COUNCIL AGENDA REPORT

SUBJECT: CONSIDER A REQUEST TO CHANGE THE ZONE FROM RM:5-12 TO RM:5-12:PD FOR A SEVEN LOT RESIDENTIAL SUBDIVISION AND APPROVAL TO DEMOLISH A SINGLE FAMILY RESIDENCE AND A 3-UNIT APARTMENT BUILDING BUILT PRIOR TO 1941. NO SIGNIFICANT ENVIRONMENTAL IMPACTS HAVE BEEN IDENTIFIED AND A MITIGATED NEGATIVE DECLARATION IS RECOMMENDED. APNS 529-16-021 AND 045. PLANNED DEVELOPMENT APPLICATION PD-05-1, ARCHITECTURE AND SITE APPLICATION S-05-15, NEGATIVE DECLARATION ND-05-03. PROPERTY LOCATION: 17005 AND 17017 ROBERTS ROAD. PROPERTY OWNER: KHURRAM IQBAL APPLICANT: LOUIE LEU ARCHITECTS

Location of Job: 17005 & 17017 Roberts Road, Los Gatos, PD-05-01, S-05-015, ND-05-03

BELLA VASONA
RESIDENTIAL
DEVELOPMENT

OPTION C/D - AERIAL VIEW OF UNITS 1 & 2

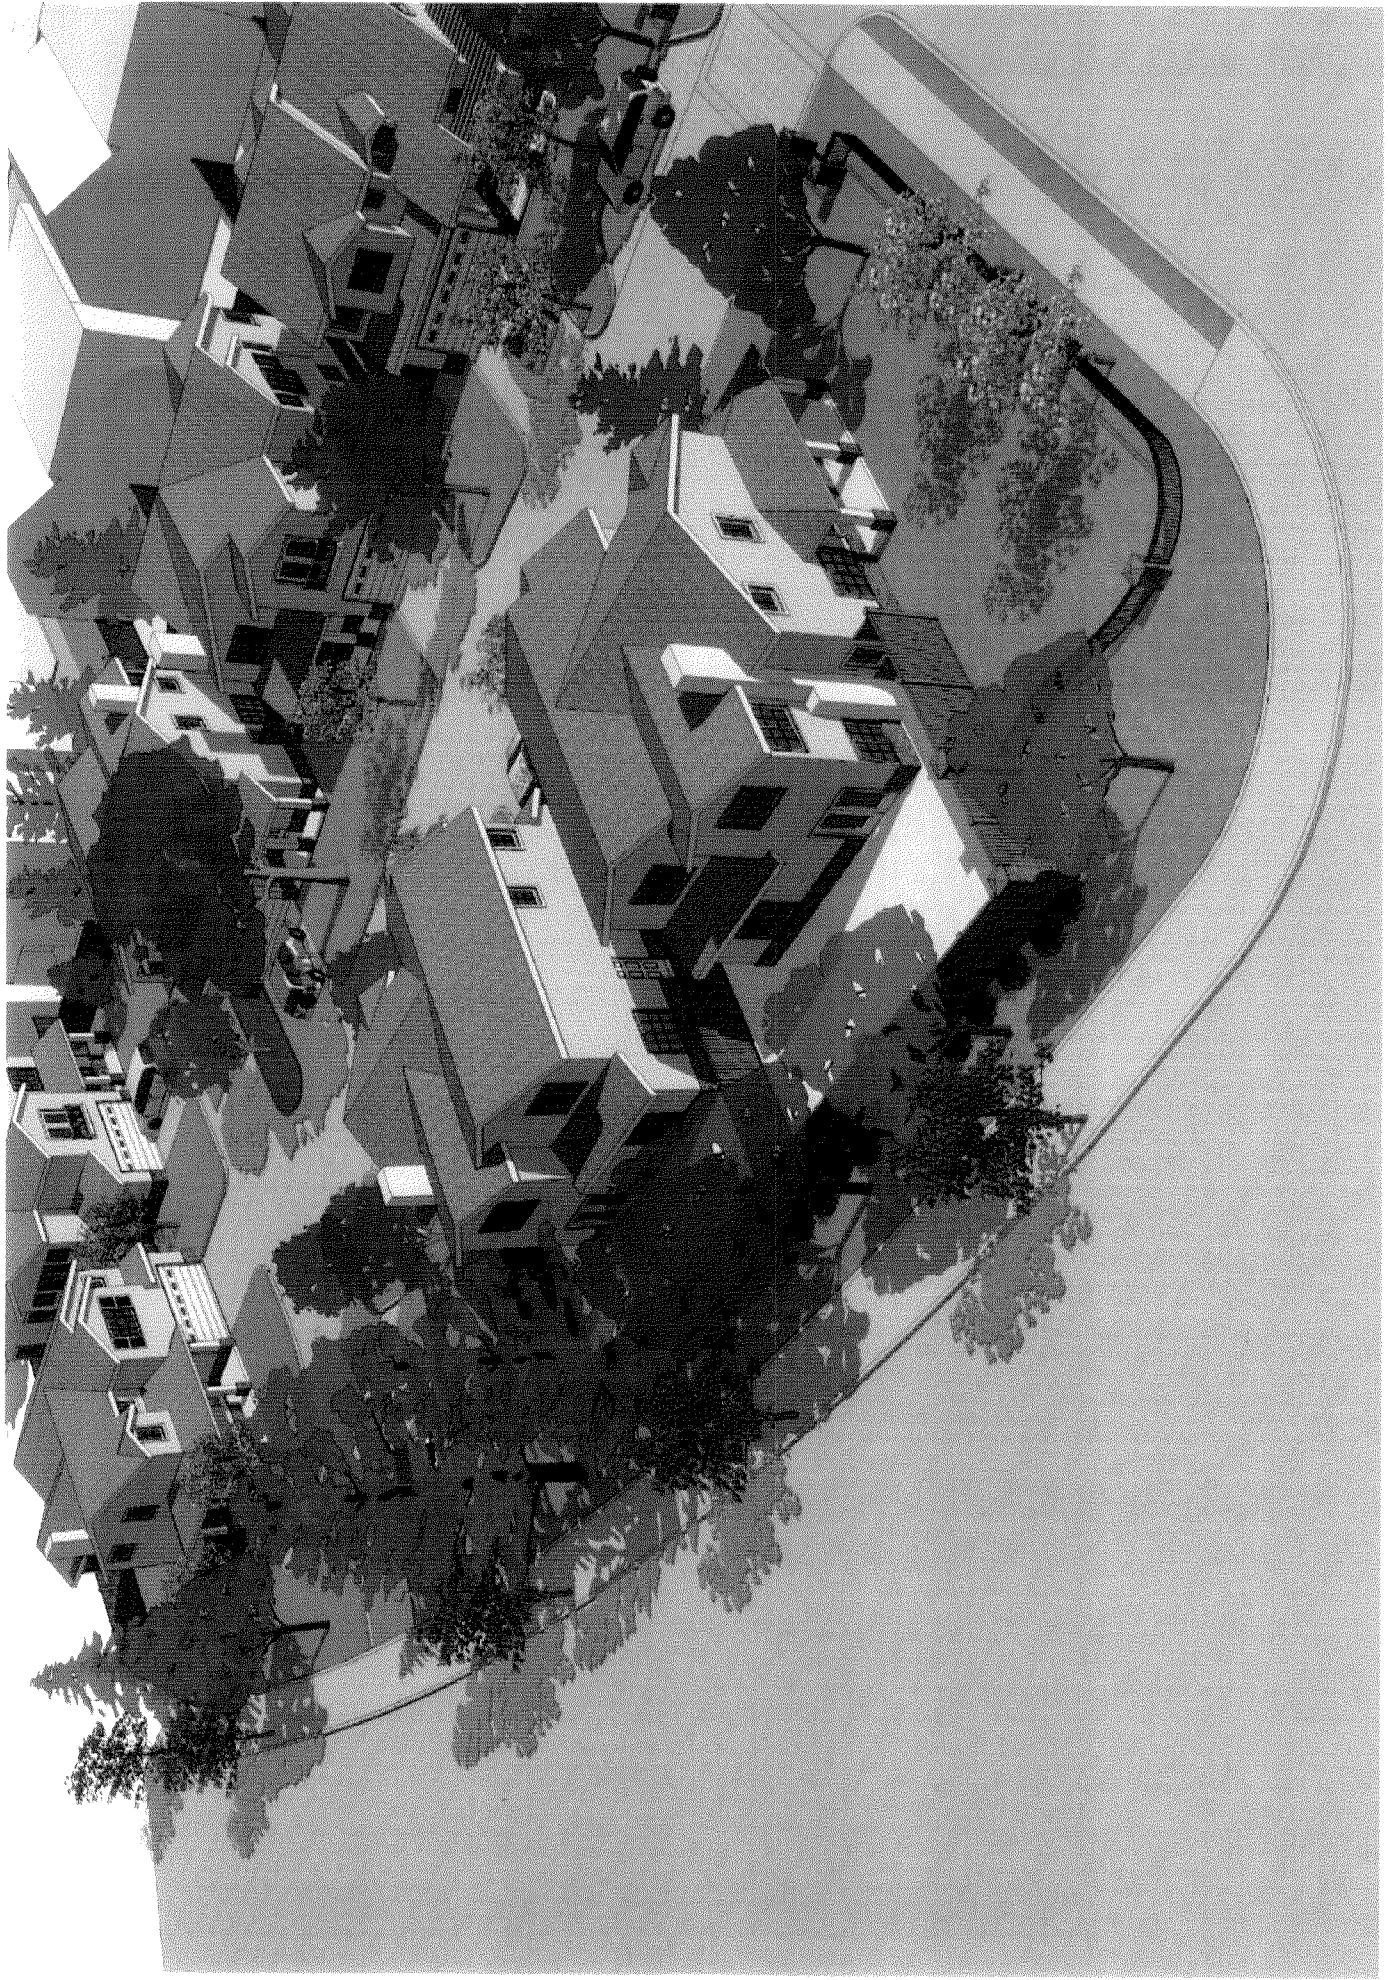
We have included 3d simulated views showing the difference between the orientation of the units and fence locations of Option "C/D" and Option "E". To illustrate how the fence might appear, we have also included literature on precast concrete fences that have a more natural wood appearance, which is similar to what we are proposing.

SITE PLAN - OPTION D

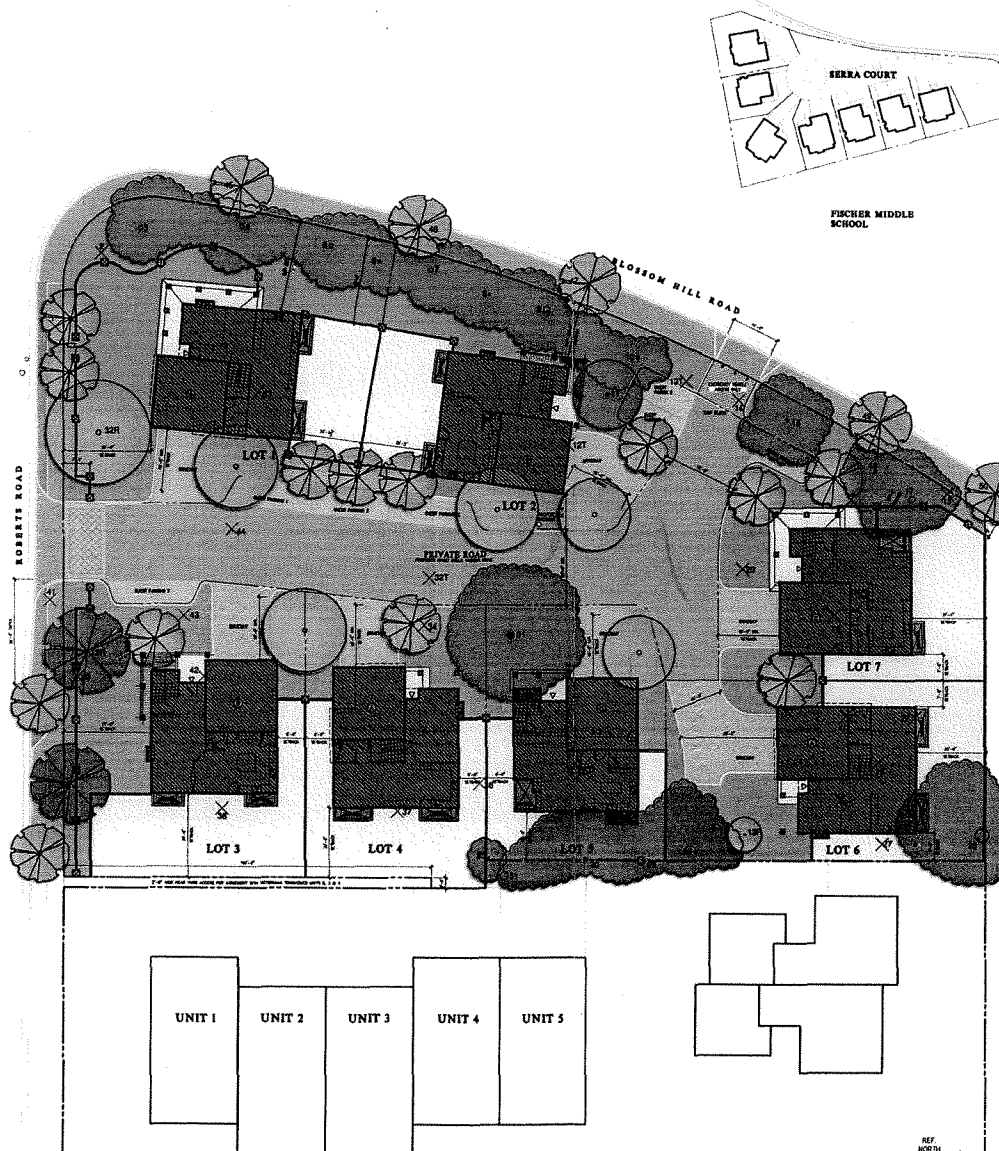
This is the applicant's preferred site plan. The following changes have been incorporated since the Council meeting:

1. The rear yard access for the abutting neighbors has been resolved (See Attachment 13). The applicant will transfer a three foot wide strip of land to the adjoining townhouse owners to provide access to their rear yards.
2. The private road area has been reduced;
3. Two guest spaces have been relocated which allows:
 - a. More private open space between Lots 3-6;
 - b. Increased side setbacks for Lots 3-5 of eight feet; and
 - c. A 20 foot rear setback for Lot 6.

1. The Fire Department would allow shortening of one leg of the hammerhead turnaround, between lots 5 and 6, since there is an emergency egress to Blossom Hill Road.
2. This would decrease the amount of private roadway, and thereby decreasing the total impervious site coverage.
3. The reduction of the private road provides the opportunity of relocating two of the guest parking spaces to the common open space near Blossom Hill Road, which then provides more private space between units 3, 4, 5, and 6.
4. Units 3, 4, 5, and 6 are re-spaced to provide 8-foot side yard setbacks between units 3, 4 and 5, and a 20-foot rear yard setback for unit 6, thus eliminating previously proposed deviations from the RM5-12 guidelines in six locations.

- THE FIRE DEPARTMENT WOULD ALLOW SHORTENING OF ONE LEG OF THE HAMMERHEAD TURNAROUND, BETWEEN LOTS 5 AND 6, SINCE THERE IS AN EMERGENCY EGRESS TO BLOSSOM HILL ROAD.
- THIS WOULD DECREASE THE AMOUNT OF PRIVATE ROADWAY, AND THEREBY DECREASE SLIGHTLY THE TOTAL IMPERVIOUS SITE COVERAGE.
- THE SHORTENING OF THE PRIVATE ROAD PROVIDES THE OPTION OF RELOCATING TWO OF THE QUEST PARKING SPACES TO THE COMMON OPEN SPACE NEAR BLOSSOM HILL ROAD, WHICH THEN GIVES MORE PRIVATE SPACE BETWEEN UNITS 3, 4, 5 AND 6.
- UNITS 3, 4, 5 AND 6 ARE RE-SPACED TO PROVIDE 8-FOOT SIDE YARD SETBACKS BETWEEN UNITS 3, 4 AND 5, AND A 20-FOOT REAR YARD SETBACK FOR UNIT 6, THEREBY ELIMINATING 2 DEVIATIONS FROM THE RMS-12 GUIDELINES.

SITE PLAN - OPTION "E"

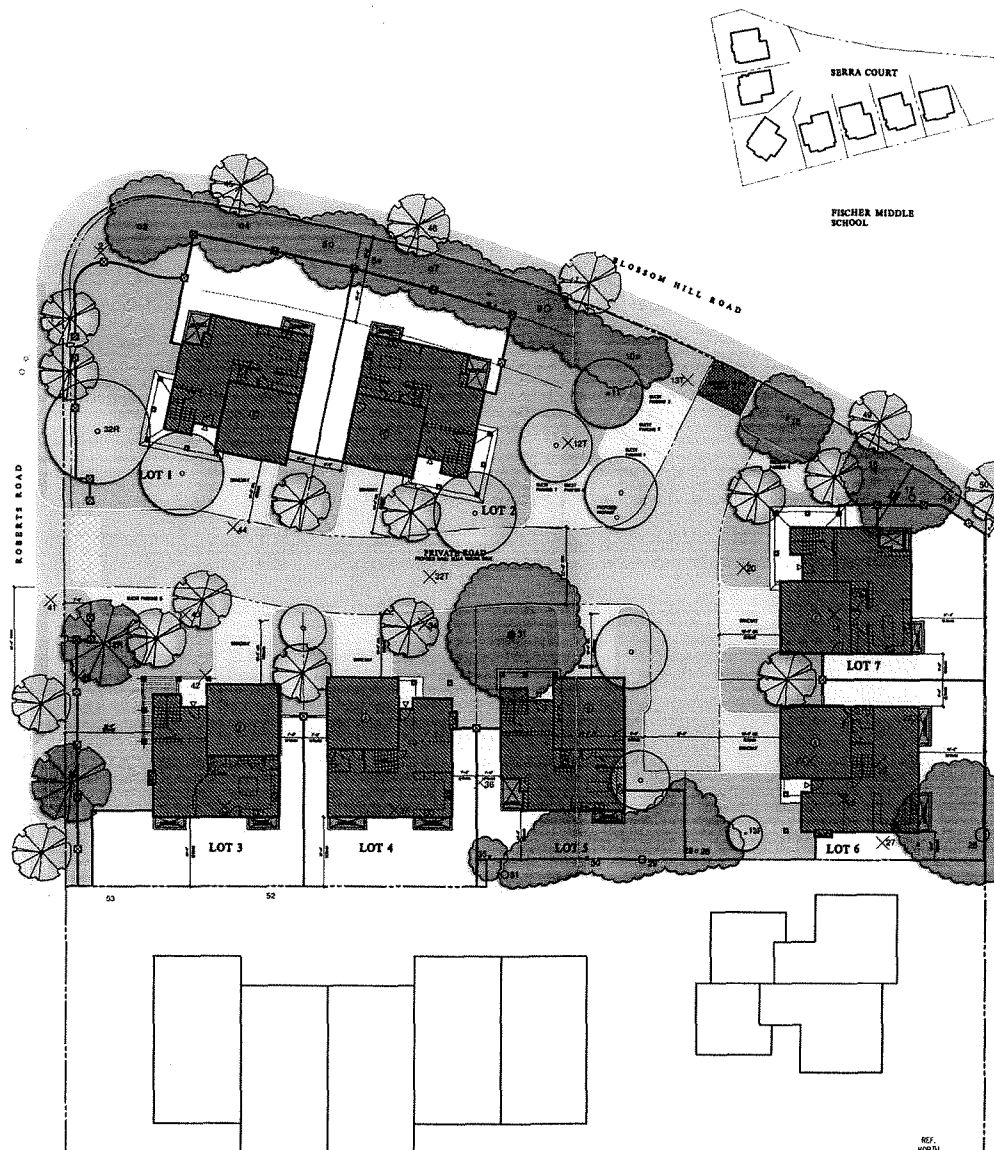
The applicant explored the option of reorienting the units on Lots 1 and 2 to face towards the south. The applicant states that this option increases the length of the sound wall adjacent to Blossom Hill Road and places the wall closer to the street. The Council should note that the "Project Description" included on the Option E site plan is incorrect.

In addition, we did explore the possibility of turning units 1 and 2 such that the fronts of the units faced the private drive, as suggested by Council member Spector. This is shown in the plan labeled Option "E". We do not like this option however, as the rear yards are subject to more sound exposure from Blossom Hill Road, and the sound wall/fence would be approximately 90 feet in length, instead of 45 feet in the modified Option "C" or Option "D". It would also be located much closer to Blossom Hill Road, and to the existing mature pines trees. This would eliminate any possibility to install a two foot berm with a 6 foot fence. Instead, there would have to be an 8-foot sound wall/fence. We also considered just turning the units and leaving the yards as they were, but this would create side yards for the units instead of back yards and eliminate the appearance of front elevations and "eyes on the street" on the Blossom Hill Road side. For these reasons, the original orientation of Units 1 and 2, with the rear yards facing each other and the reduced length and height of the sound wall/fence is the better option.

- THIS IS THE ORIGINAL PROPOSED SCHEME WITH MODIFIED SOUND WALL LOCATION
- THE SOUND WALL BETWEEN LOT-1 AND LOT-2 IS MOVED FURTHER FROM BLOSSOM HILL ROAD, APPROXIMATELY 25'-0" FROM THE PROPERTY LINE AND 15'-0" AWAY FROM THE EXISTING SHIR TREES, WHICH ALLOWS ADEQUATE ROOM TO HAVE A 2'-0" HIGH BERM AND 6'-0" HIGH WALL
- THE VISIBLE LENGTH OF WALL IS REDUCED FROM 68'-0" TO 45'-0"
- GUEST PARKING AND PRIVATE DRIVE IS NOT VISIBLE FROM BLOSSOM HILL
- GUEST PARKING SPACES ARE ADJACENT TO THEIR RESPECTIVE LOTS
- THE PERCENTAGE OF ROADWAY, GUEST PARKING AND OPEN SPACE TO PRIVATE LOT AREA IS 18% THIS COMPARES TO SERRA COURT WHICH IS 26%
